Our Ref:239848  
Department Ref: SSD-9827

**RE: PART LOT 4 DP 1238761,  
45 HONEYSUCKLE DRIVE, NEWCASTLE.**

Thank you for your letter dated 5 November 2019 providing the Departments request for additional information in relation to the above application following further assessment. Please accept this submission as our formal response to the matters raised.

**Figure 1 – Mass Exceeding LEP Envelope (after application of allowable LEP bonus of 10%).**

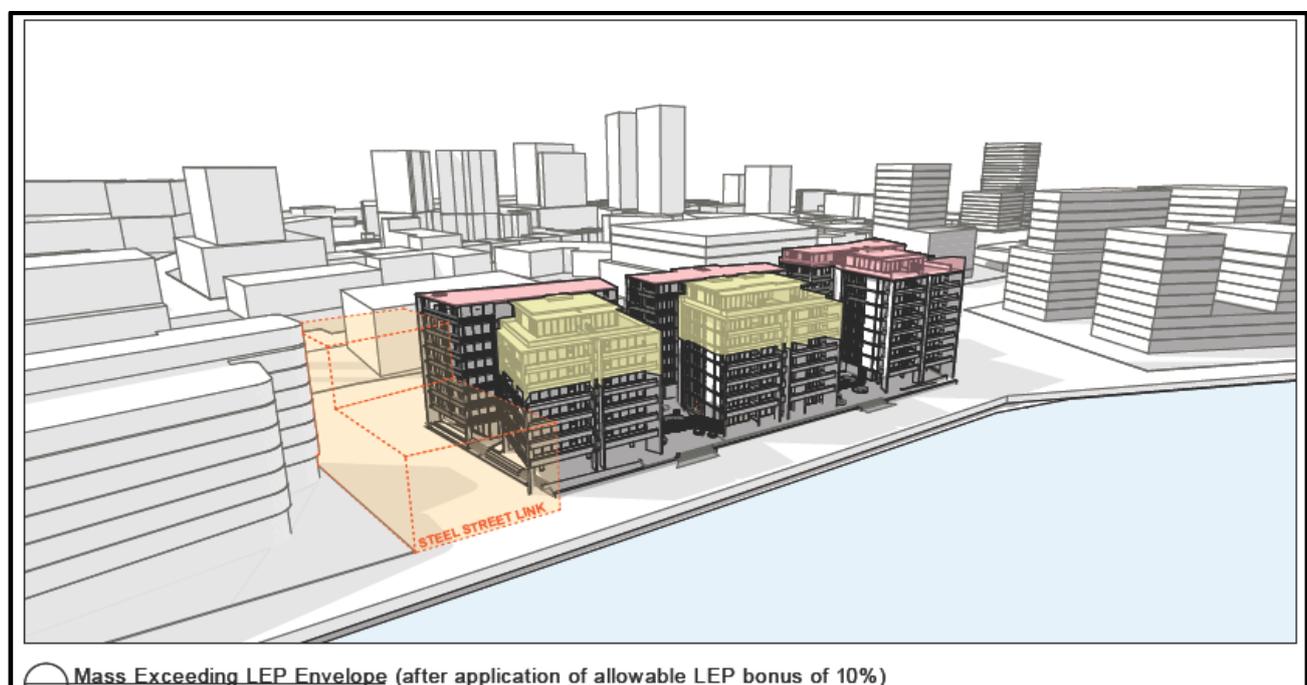
Provide further justification for the proposed variations to the height and floor space ratio controls under the Newcastle Local Environmental Plan 2012, including consideration of:

- the overshadowing impacts of the proposal compared to a complying development;
- the visual and view impacts of the proposal compared to a complying development, from the foreshore, waterway and neighbouring properties to the south; and
- how the proposed variation allows for improved public domain outcomes.

The proposed variation in building height is identified in **Figure 1** below.

When viewed from the foreshore and water the variations will be of negligible impact and mostly imperceptible. The additional height for the north east building elements are lower than the elements behind and on the same site. While the southern and western portions comfortably sit within the context of the surrounding built form noting the height limit of 30m immediately to the south of the site and then 90m, 45m and 30m to the west. Furthermore, we strongly believe that the small variation is an appropriate transition of built form from the east to west and from north to south.
